305 S. CONGRESS PUD

### COMMENT REVIEW REPORT

This report includes all comments received to date concerning your planned unit development. The planned unit development will be approved when all requirements identified in this report have been addressed. However, until this happens, your planned unit development is considered disapproved.

*Figure 1: SCWP envisioned land-sharing for the Barton Springs East Extension*

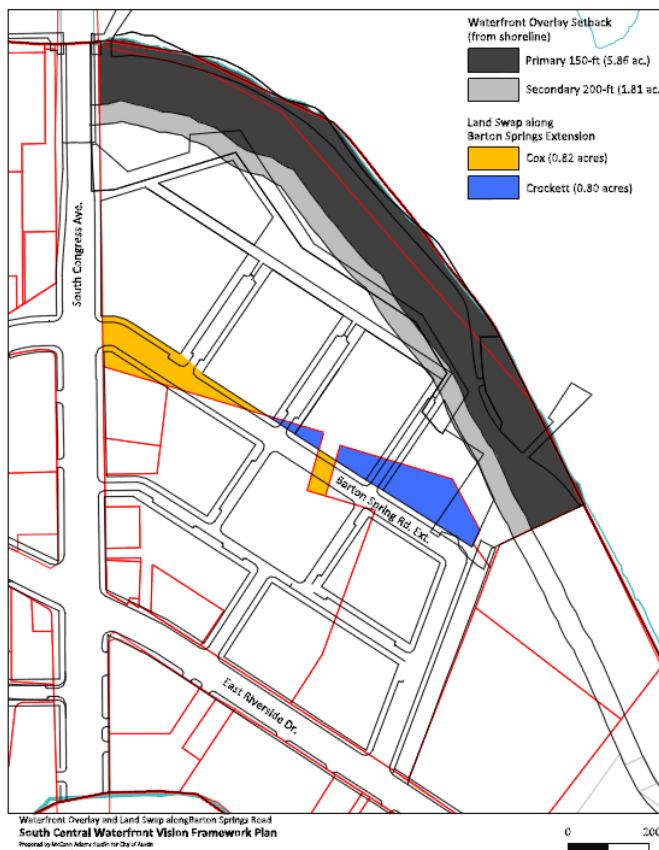
- The SCWP envisioned that the Barton Springs East Extension would place the majority land contribution burden on the Crockett property. According to the SCWP, the 305 S Congress site would contribute 0.82 acres (as shown in Figure 1 in Yellow) towards this street while gaining a roughly equivalent 0.8 acres from the Crockett property (next page, as shown in Figure 1 in Blue) towards the development of the 305 S Congress site., The PUD proposal includes a land contribution (1.61 acres) that would have been otherwise available for development.
  - The SCWP would deem this contribution as a community benefit that should count towards the Applicant's in-kind, on-site community benefit contribution.
